Front Axle Wedge, Installation CHU

PI0850, Front Axle Wedge, Installation

(May 2014)

W7089865

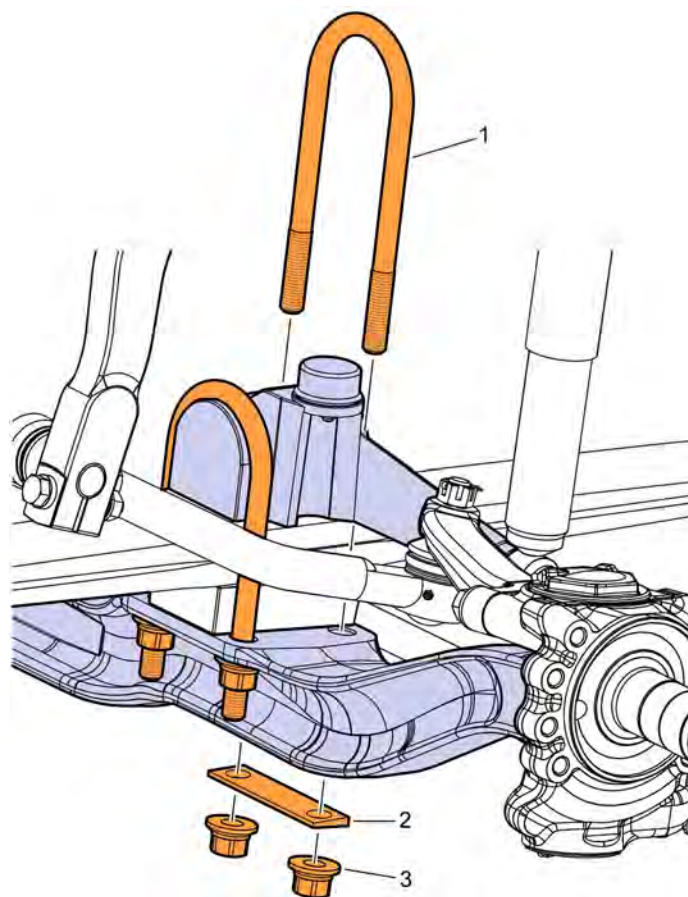
- 6 Remove the u-bolt (1), wedge (2) and nuts (3) from the front axle.

Note: Left side shown.

Note: Remove the u-bolts one at a time as shown in the figure below.

Note: Do not discard the existing wedge. Clean the wedge of any debris and store for reuse.

W7089867

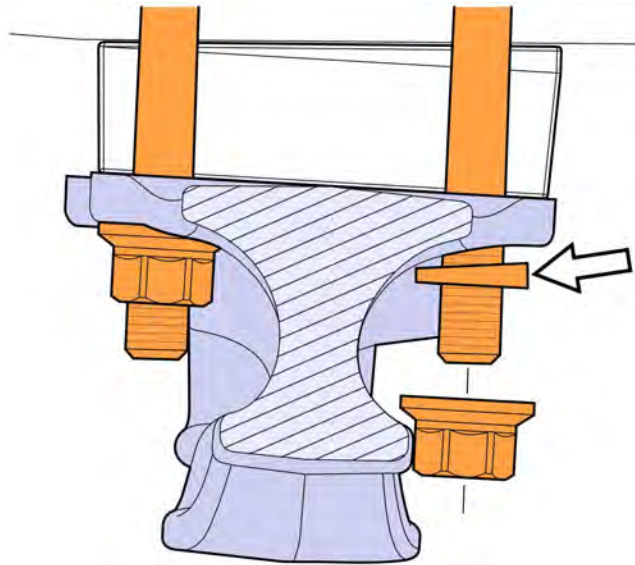
7 Position the u-bolt, wedge and nuts on the front axle as shown.

Note: Use the existing wedge.

Note: Ensure the wedge is installed with the thick side facing rearward.

Note: Ensure the front axle locating features are utilized.

Note: Do not tighten the fasteners at this time. See the torque sequence chart after installation of both U-bolts.
